# **Environmental Protection Authority**

# NOTICE OF DECISION TO CONSENT TO CHANGE TO PROPOSAL DURING ASSESSMENT

Earl Grey Lithium Project Assessment No. 2123

Figure 1. Revised Mine Layout

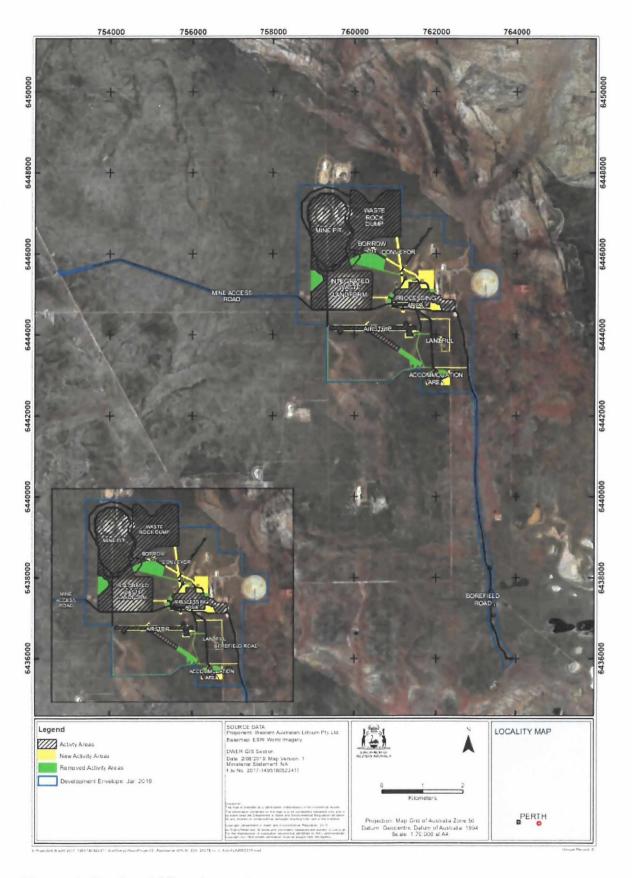
- Decreasing the area required for the Run of Mine (ROM) and relocating the ROM to areas of existing disturbance resulting in a reduced impact to Microcorys sp Mt Holland population and the associated MW7 vegetation community;

- Removal of the lower portion of the old airstrip from the disturbance footprint
  previously planned for topsoil storage and avoidance of the large southern
  population of Banksia sphaerocarpa var. dolichostyla and Microcorys sp. Mt
  Holland;

- Removal of the southern access road from the disturbance footprint that
  previously intersected Banksia sphaerocarpa var. dolichostyla and Microcorys
  sp Mt Holland populations resulting in reduced direct and indirect impacts;

- Reorientation of the Accommodation Village to avoid indirect impacts to Banksia sphaerocarpa var. dolichostyla and Microcorys sp. Mt Holland;
- Removal of a portion of the Integrated Waste Landform (IWL) to minimise impacts to *Microcorys sp.* Mt Holland and inclusion of:

- o an option for a conveyor from the Waste Rock Dump (WRD) to the processing area as well as an option to transport ore instead of heavy haulage vehicles along the haul road;

- o access road between the IWL and Processing area;

- additional areas surrounding the airstrip required for construction and operation (including fencing);
- o realignment of the haul road from the WRD to Processing area;
- Utilisation of the existing/historical site borrow pit area for minor road maintenance and the establishment of earthen pads as part of the Minor or Preliminary Works (MPW); and
- Addition of a new landfill in an area of existing disturbance for the disposal of putrescible and construction waste as part of the MPW.

See Figure 1 and Schedule 1 attached.

Figure 1. Revised Mine Layout

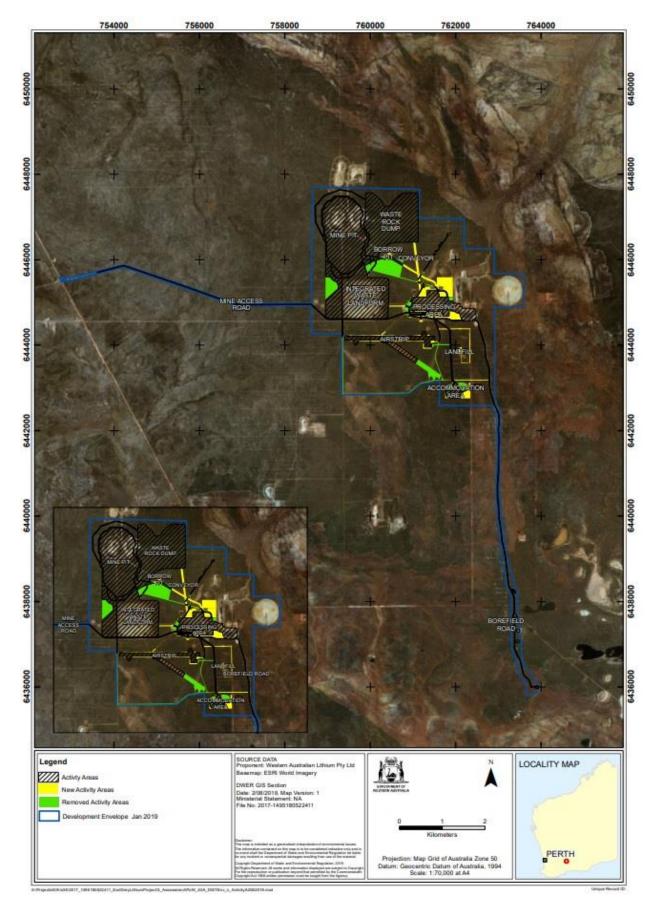
Several changes were proposed including decreasing the area required for the Run of Mine (ROM) and relocating the ROM to areas of existing disturbance, removal of the lower portion of the old airstrip from the disturbance footprint, removal of the southern access road from the disturbance footprint and removal of a portion of the Integrated Waste Landform (IWL).

Overall there is an increase in the disturbance footprint, however, there is an increase in use of already disturbed areas resulting in a reduction of total clearing by 6 hectares (ha) (Table 1). The utilisation of existing disturbed areas also results in a reduction of clearing and impacts to Threatened and Priority flora, *Banksia sphaerocarpa var. dolichostyla* and *Microcorys sp.* Mt Holland (Table 2).

Furthermore, it is noted that the option for a conveyor from the Waste Rock Dump (WRD) to the processing area will reduce the reliance on heavy haulage vehicles along the haul road. This may lead to a reduction in dust emissions and the requirement for dust suppression along the haul road.
